Representation Number 28905

Policy SER1 North of London Road, Rayleigh (and supporting text)

Figure 1 – Green Belt boundary using pylon line.

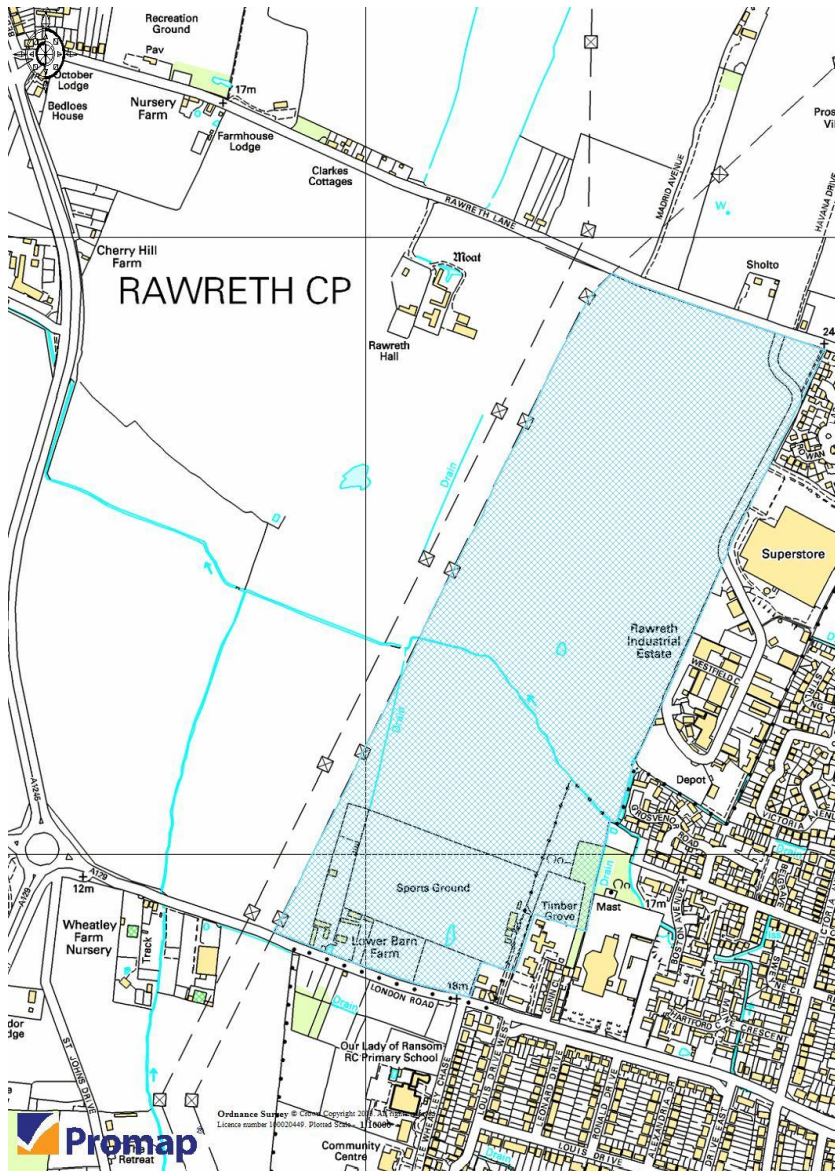
In accordance with our comments above, at the very least, if the pylon line is to be used as a physical marker for the Green Belt boundary, then it should be applied consistently, and the arbitrary 60m off-set for part of its length removed, such that the Green Belt boundary/allocated site would be as shown on the plan at Figure 1 overleaf:

Figure 2 – NPPF and Core Strategy compliant boundary.

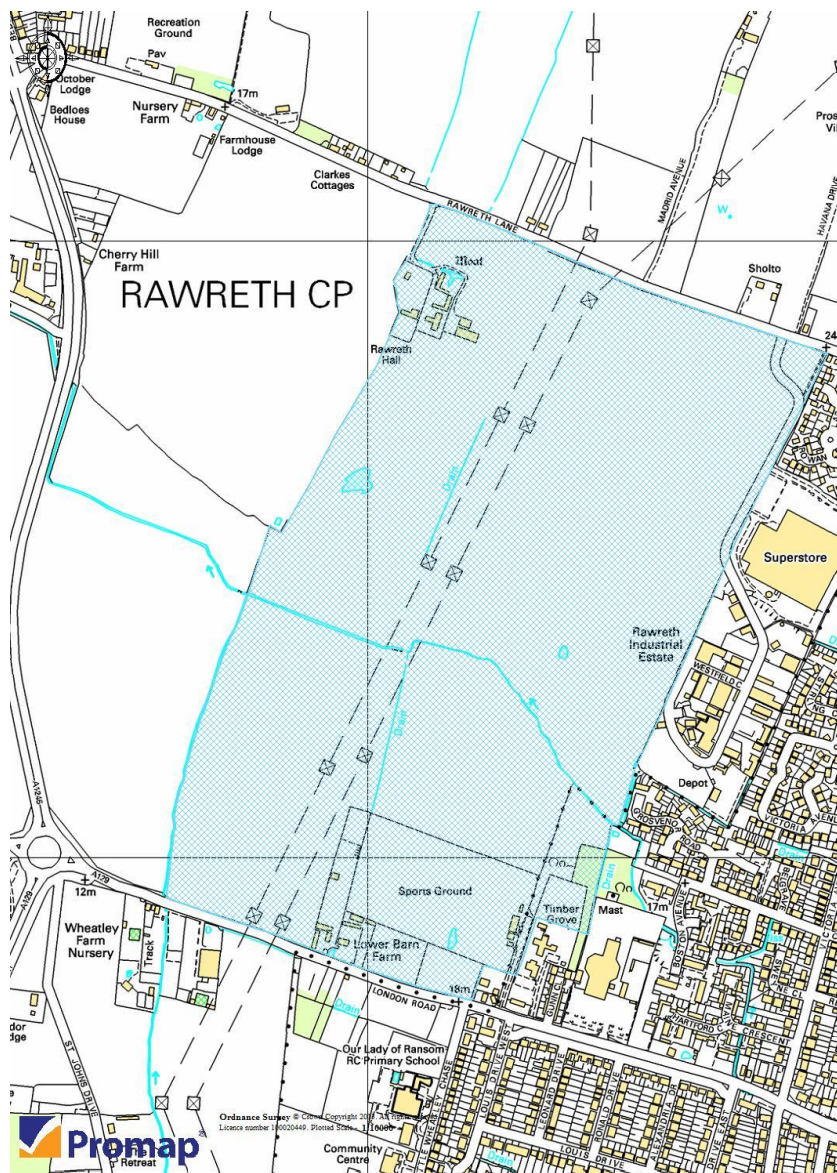
However, to properly comply with the NPPF and the adopted Core Strategy, then as per our submissions above the Green Belt boundary should be defined for the long-term, taking account of physical features, and provide the flexibility necessary to ensure that the requirements of the Core Strategy can be met. The proposed alternative boundary is shown on Figure 2 overleaf.

Of course, it does not follow that the proposed housing itself would extend to the west of the Pylon line, even with the proposed revised boundary. The Concept Statement requires a green buffer to the west of the development, and even though excluded from the Green Belt, there is no reason why the land between the pylons and the revised boundary cannot stay open and used for such purposes.
